ADDENDUM No. 1

PROJECT NAME: Alamodome Boiler Replacement

PROJECT NO: 45-00052

SHEET NO.
MD1.1

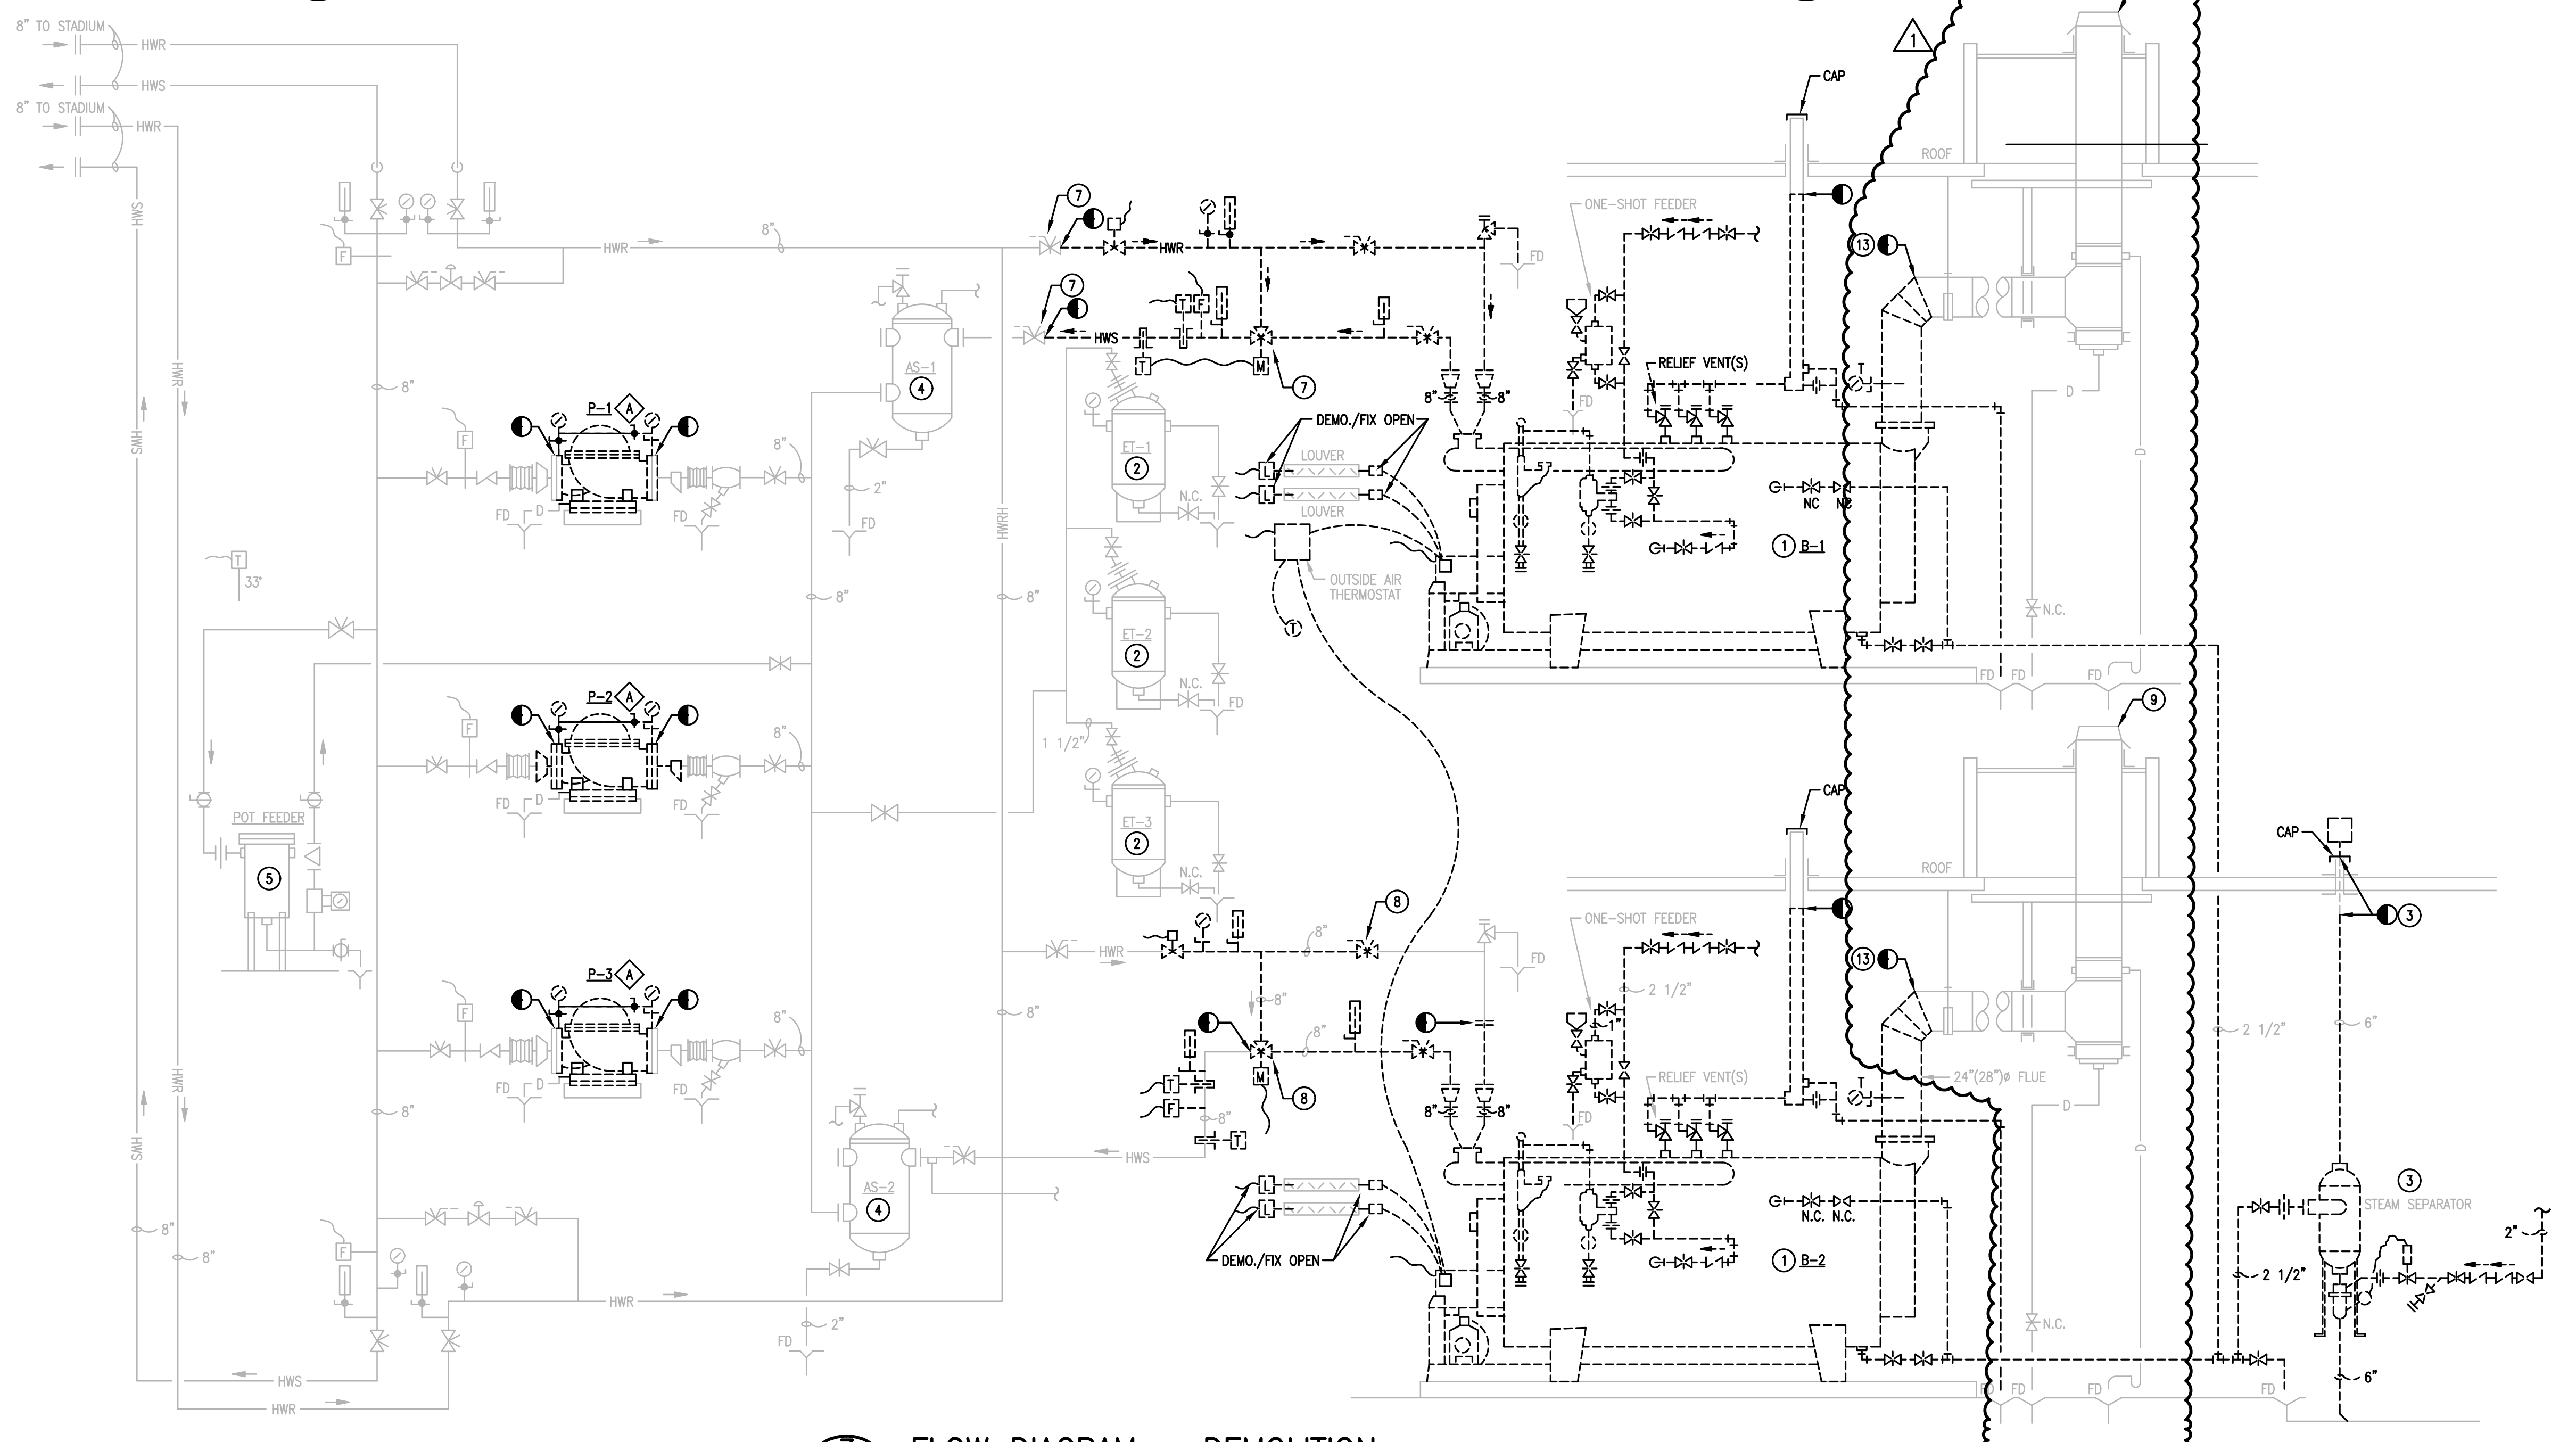
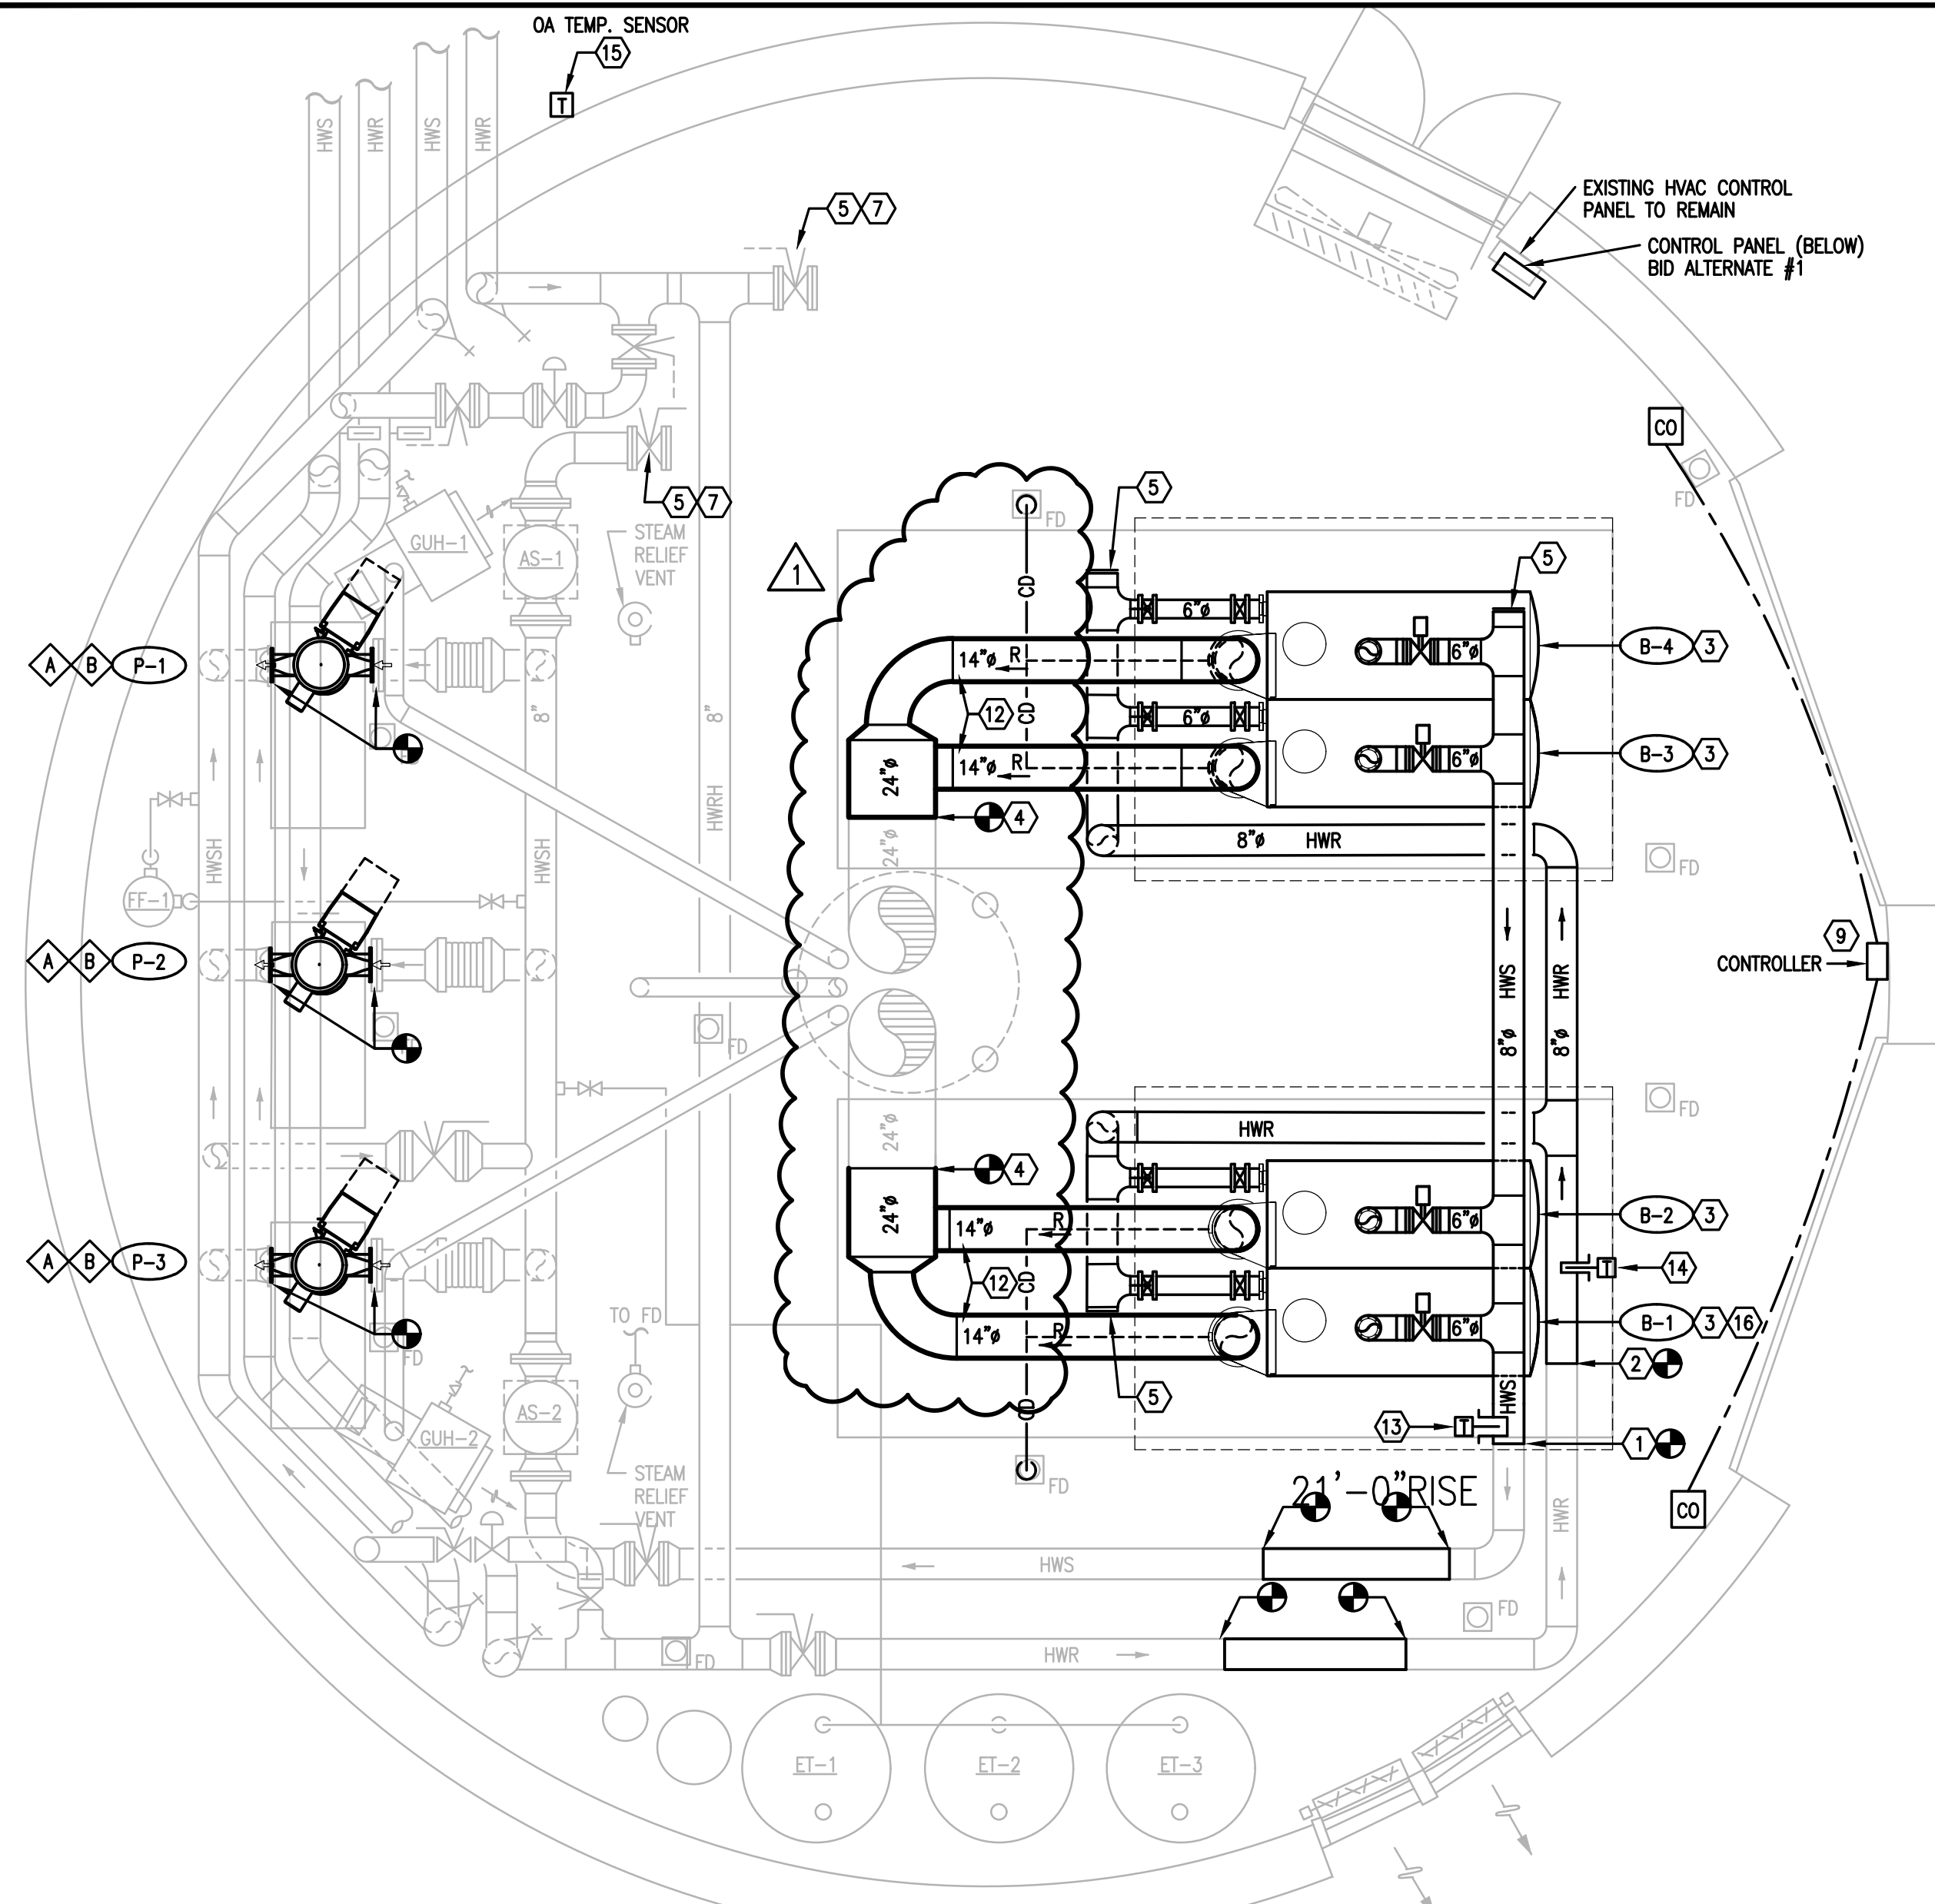
1. SHEET MD1.1 – REVISE DELMOLITION EXTENT OF EXISTING BOILER FLUE.
2. SHEET M1.1 – REVISE BOILER FLUE CONFIGURATION.
